SUBJECT: WESTINGHOUSE RESPONSES TO NRC REQUESTS FOR ADDITIONAL
INFORMATION ON THE AP600

49 Discussion Items and 3 Additional Items

"Scaling Analysis for AP600 Containment Pressure
During Design Basis Accidents"

Responses to 49 Discussion Items and 3 Additional Items

Figure 1 Buoyancy Calculation for the AP600 PCS Air Flow Path Comparing Distributed and Thermal Center Approaches

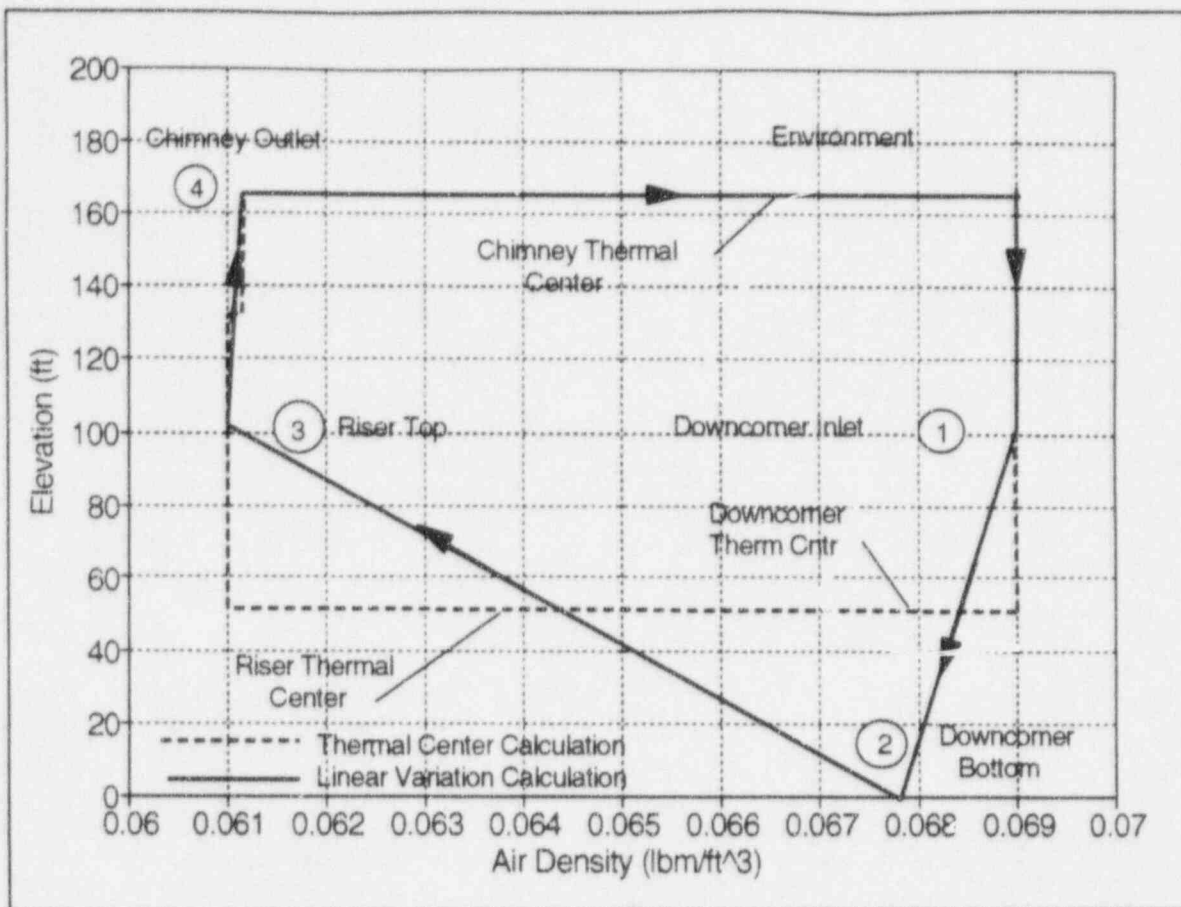
28. The buoyancy term (equation 102) is stated to be in terms of "thermal center"

differences. It is difficult to tell from Figure 8, just how H1, H2, H3 and H4 are defined. However, the densities, ρ_{dc} , ρ_{ri} , ρ_{ch} and ρ_{nv} are calculated based upon exit temperatures. If H2 - H3 is the riser height, then using a density based upon exit temperature will overestimate the buoyancy force by about a factor of about 2, since the average density should be used. Please explain how your approach accounts for the variation in density along each segment of the flowpath.

28. Figure 9-1 of WCAP-14845 clarifies the location of thermal centers. The discussion in Section 9.3.1 and Figure 9-2 show how the thermal centers are used with the density to calculate the buoyancy. The example calculation in WCAP-14845 is repeated below.

Figure 1 shows an example of a simplified PCS buoyancy calculation using density values calculated for the beginning of the long term time phase of the LOCA. The density variations over each leg of the air flow path are assumed to be linear. The net buoyancy is represented by the enclosed area. The buoyancy calculated using the thermal center approach is shown for comparison. For this case both the distributed density and thermal center approaches give the same result. Note that for this assumed case, the net buoyancy is not affected by the amount of heat transferred from the riser to the downcomer. (Moving point 2 along the horizontal axis does not change the area within triangle 1-2-3). However, moving point 2 does change the relative ratio of negative downcomer buoyancy to positive riser buoyancy. Moving the thermal centers of the downcomer and riser up to the 84 ft elevation, as was done for the AP600 scaling calculation, significantly reduces the net buoyancy.
